N5222A-02

S E R V I C E N O T E

N5222A PNA Series Microwave Network Analyzers

Some analyzers are exhibiting unlocked or unleveled errors or other unexpected digital control faults. Analyzers that experience any of the symptoms listed on page 2 of this document must be inspected for a possible return to Agilent to have the system motherboard replaced.

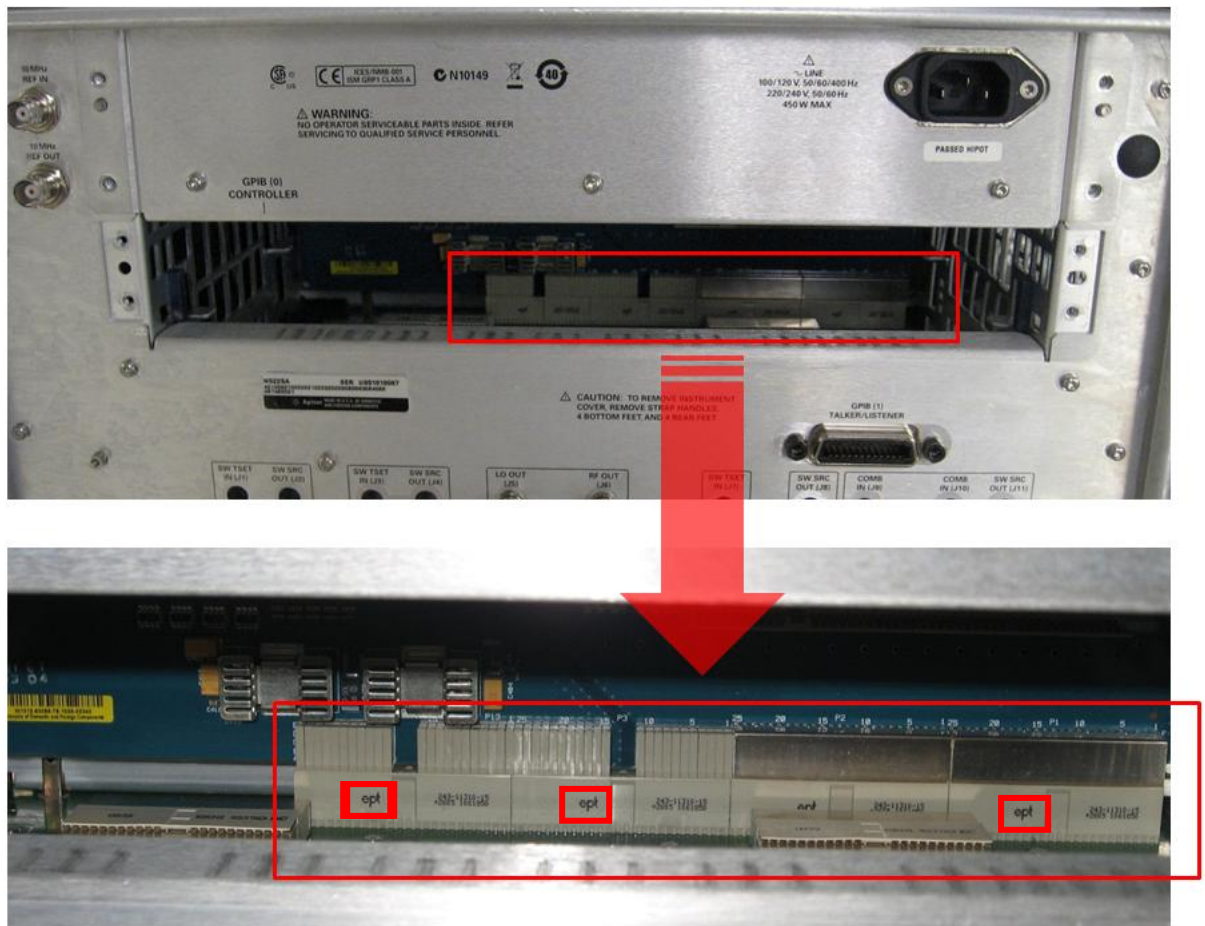
1. Remove the CPU assembly from the analyzer's rear panel. Refer to the PNA Service Guide chapter 7 section titled, "Removing and Replacing the CPU Board Assembly" for removal and reinstallation procedures. To view the online Service Guide, see the numbered list on the next page for instructions.
2. As per the photo below, inspect the system motherboard connector to see if it has one or more "ept" logos.

3. If the connector has one or more “ept” logos, return the analyzer to Agilent for replacement of the system motherboard. If the connector does not have one or more “ept” logos, email support_ctd-soco_support@agilent.com, providing the analyzer model and serial number and details of the malfunction symptoms.

4. *For Agilent Service Technicians only:* Only new boards without “ept” logos should be installed. Before installing the new board, look to see if it has one or more “ept” logos. If so, email support_ctd-soco_support@agilent.com, providing the analyzer model and serial number. Wait for further instructions in an email reply. New boards without “ept” logos can be installed.
For installation instructions, refer to the PNA Service Guide chapter 7 section titled, “Removing and Replacing the System Motherboard.” To view the online Service Guide, see the numbered list on the next page for instructions.
